Service Bulletin

EGC1500C2/EGC1250C2 Fan Replacement

Product Group: Power Solutions	Date Issued: 01/26/2011	Service Bulletin No. GSP20110126																											
Bulletin Type		Models/Series Affected:																											
<input checked="" type="checkbox"/> Mandatory <input type="checkbox"/> Information Only <input type="checkbox"/> Recommended Change		EGC1500C2 <table border="1"> <tr> <td>WA-566888-0908</td> <td>WA-562490-1207</td> <td>WA-571154-1109</td> <td>X07M520360</td> <td>X08C110806</td> </tr> <tr> <td>WA-560675-1007</td> <td>WA-566893-0908</td> <td>WA-563507-0408</td> <td>X08C110803</td> <td>WA-566908-0908</td> </tr> <tr> <td>WA-567038-1008</td> <td>WA-566899-0908</td> <td>WA-562394-0408</td> <td>X8A030654</td> <td></td> </tr> </table> EGC1250C2 <table border="1"> <tr> <td>WA-564238-0208</td> <td>WA-563766-0208</td> <td>WA-564196-0208</td> <td>WA-564226-0208</td> <td>F080189849</td> </tr> <tr> <td>WA-564198-0208</td> <td>WA-563762-0208</td> <td>WA-564267-0308</td> <td>WA-564149-0208</td> <td></td> </tr> </table>			WA-566888-0908	WA-562490-1207	WA-571154-1109	X07M520360	X08C110806	WA-560675-1007	WA-566893-0908	WA-563507-0408	X08C110803	WA-566908-0908	WA-567038

Figure 1. Fan Replacement Parts

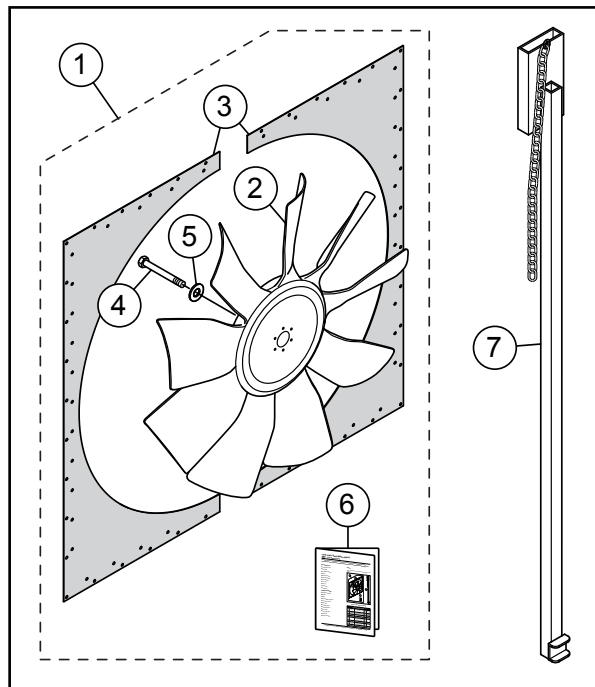
During normal operation, the fan is spinning at 990 rpm, and harmonic distortion causes the fan to vibrate. Excessive fan vibration may cause the fan blades to fail.

Replace fan and shroud. Refer to Instructions P/N 55738 for procedure.
